TABLE OF CONTENTS

QUERY 1

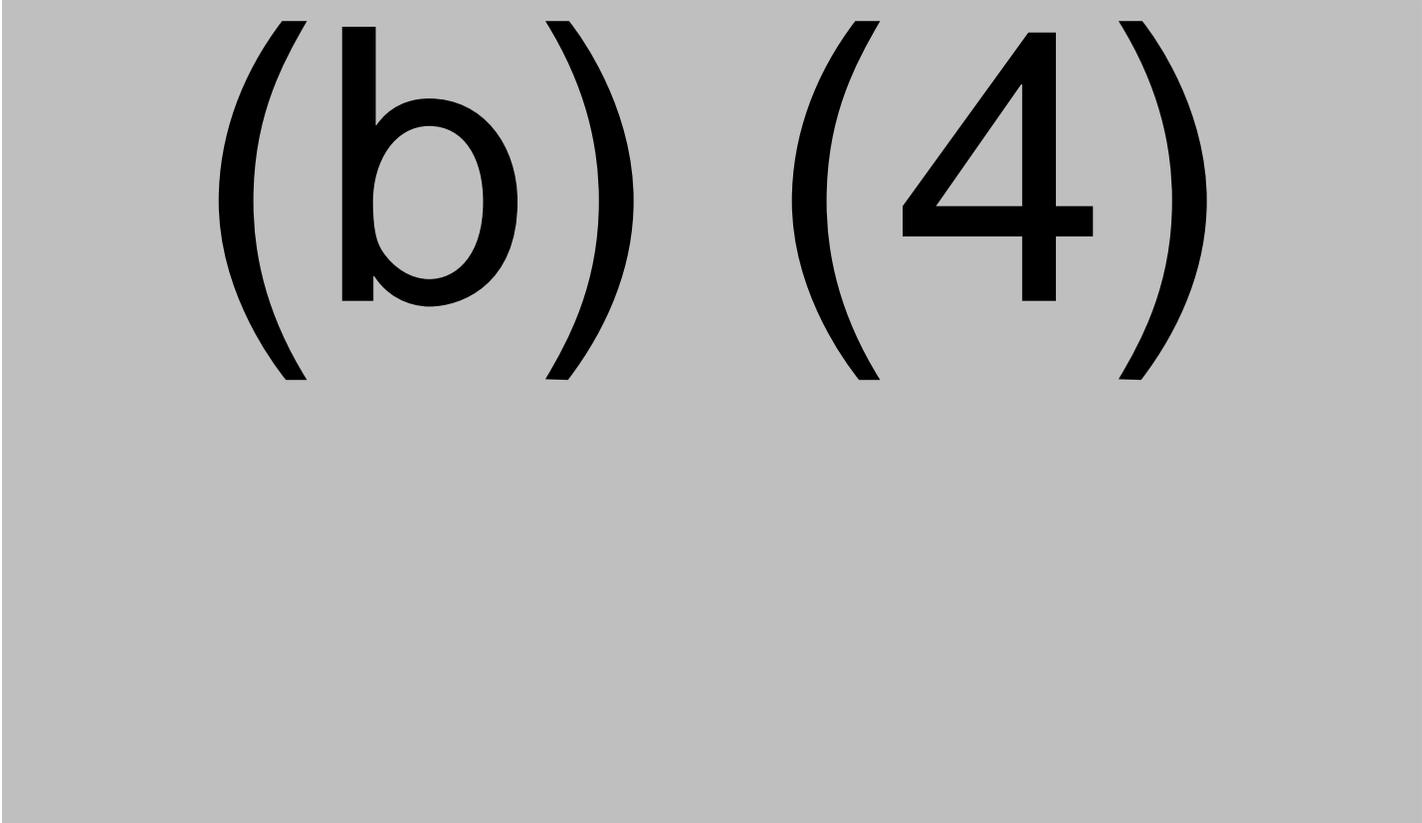
In your validation report for the 5'-cap assay for drug substance (VAL100136648), the accuracy study report includes a calculation of (b) (4) (b) (4) (b) (4) Please explain how you obtained the (b) (4) (b) (4) values in attachment 8.
